# **Decision Report**

# **Application for Works Approval**

Works Approval Number W6541/2021/1

Premises Paddington Gold Ora Banda Operation Landfill

Figure 1: Proposed Ora Banda Landfill design

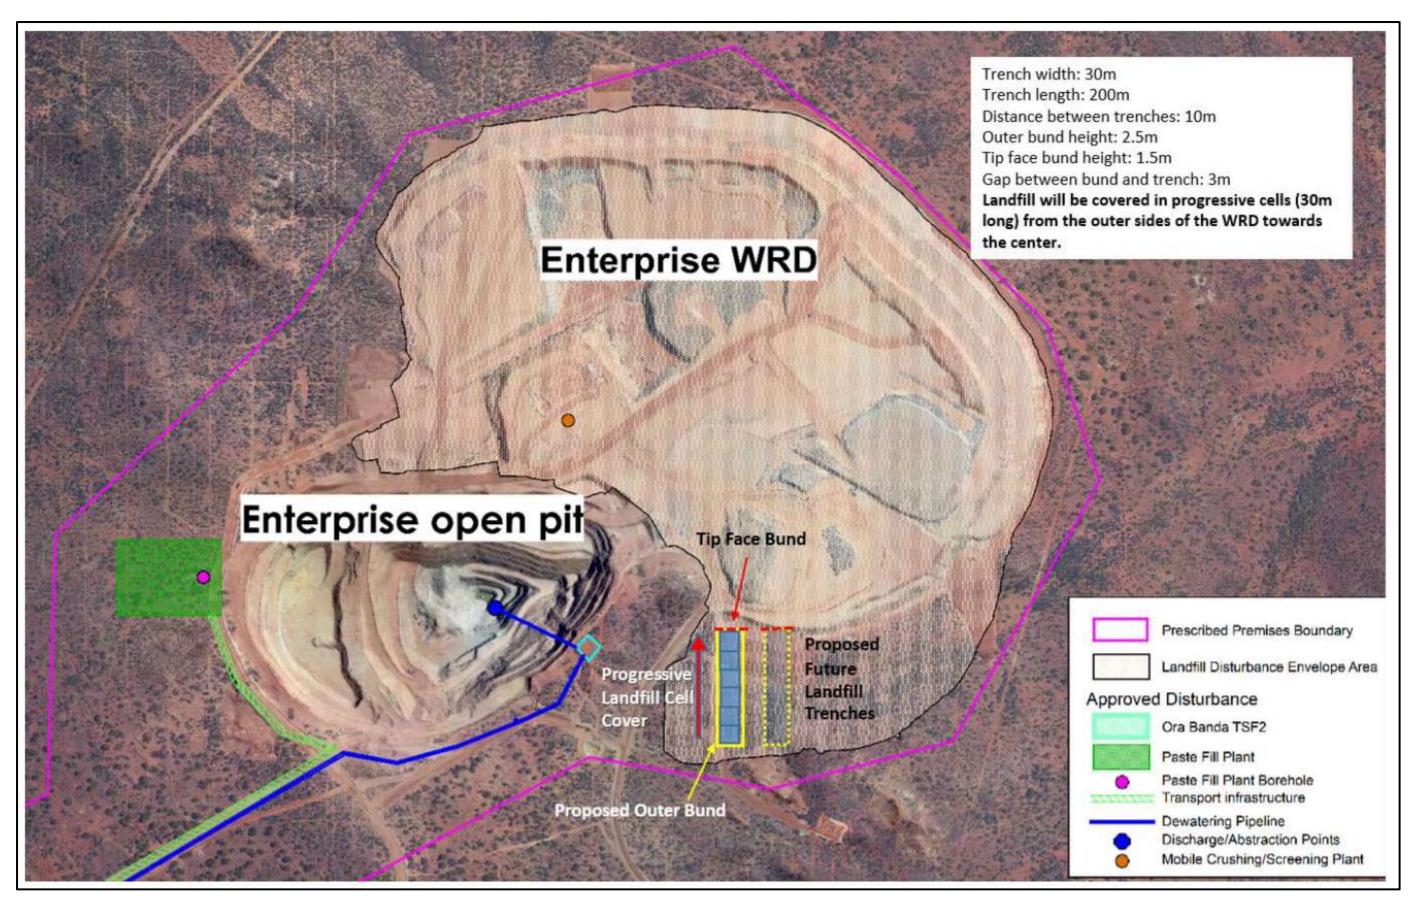
Condition/Section	Summary of applicant's comment	Department's response
		DWER requested clarification of the number of landfill trenches that the applicant proposes to build.
Condition 1 Table 1 of the Works Approval	Applicant has responded that the number of intended landfill trenches at the operation will be 2.	DWER requested clarification of the number of landfill trenches that the applicant proposes to build.
Figure 2 of the Decision Report and the Figure 2 in the Schedule 1 on the Works Approval	Applicant has provided a new diagram for landfill design cross- section and the proposed landfill trench length has changed into 100m from 200m.	DWER noted the change and included in the final instrument.
